Technical Service Bulletin

TSB0405: CM Cylinder Heads

February 10, 2005

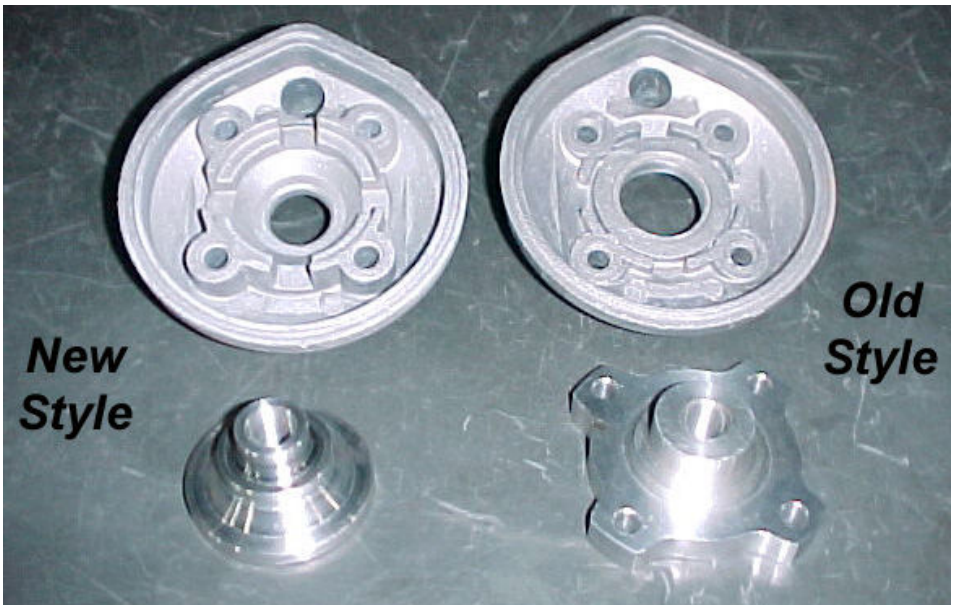
As of Cobra CM model motorcycle serial number CM70905076, manufactured February 10, 2005, the CM will be assembled with the same style of cylinder head as the 2005 King. The two versions of cylinder head perform identically, and measure the same from the combustion chamber side but are assembled differently as the photo shows.

The two configurations require different top-end o-ring sets. The table on the following page will help sort and organize gasket kits for these and earlier models.
